2003 Ford Mustang V8-4.6L SOHC VIN X

## INTERIOR - PASSENGER SEAT SQUEAKING SOUND

03-1-5

TRIM - PASSENGER SEAT RUBS AGAINST DOOR PANEL

Figure 1

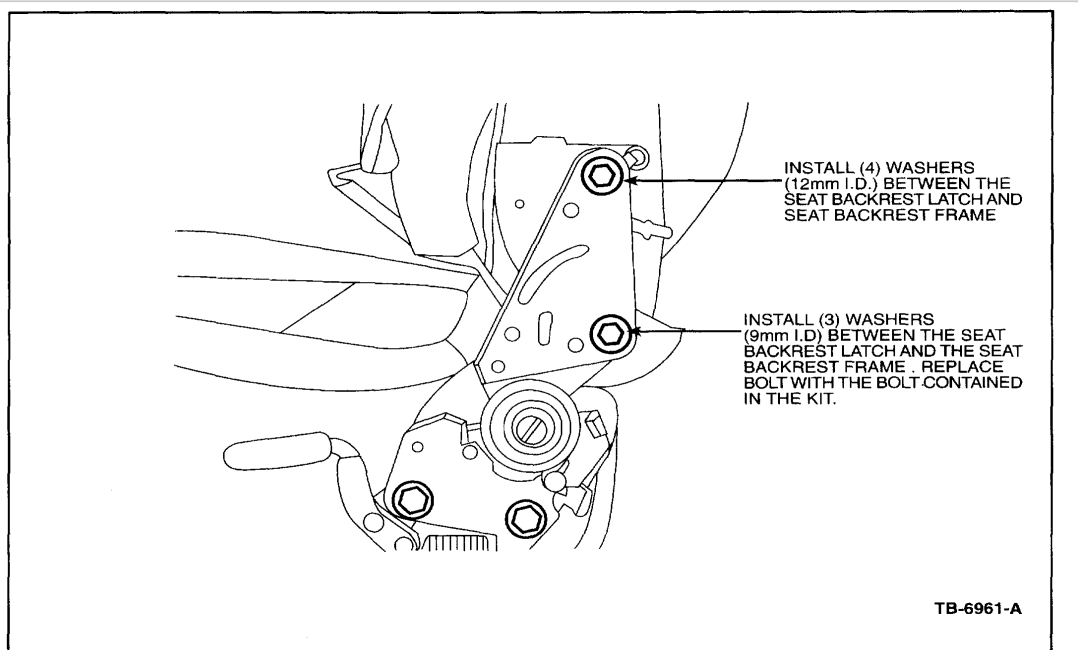
2. Remove the front passenger seat backrest and latch per Workshop Manual procedure listed in Section 501-10. Only remove the top two bolts of latch (Figure 1). Discard lower bolt.
3. Obtain Seat Shim Kit 1R3Z-63000A25-AB.

**Figure 2**

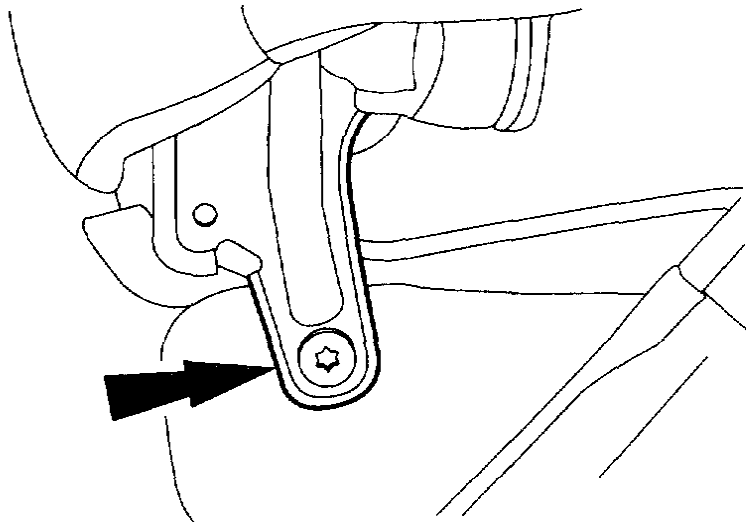
**INSTALL (4) NEW WASHERS (12mm I.D.) BETWEEN  
BRACKET AND SEAT CUSHION FRAME**

4. Install four (4) of the 1.5 mm-thick washers (8 included in kit with a 12.1- 12.4 mm I.D.) between the seat backrest bracket and the seat bottom cushion frame (Figure 2).
5. Install other four (4) of the 1.5 mm-thick washers between the seat backrest latch and the seat backrest frame at the upper bolt location (Figure 1).
6. Install the three (3) 2 mm thick washers (smaller I.D.) between the seat backrest latch and the seat backrest frame at the lower bolt location (Figure 1).
7. Using the bolt that is provided in the kit for the lower hole, Re-install the seat backrest latch using the reverse of the procedure listed in Section 501-10.
8. Re-install the seat backrest using the reverse of the procedure listed in Section 501-10.
9. Re-install seat into vehicle using the reverse of the procedure listed in Section 501-10. Slide seat towards center console before tightening seat to floor.
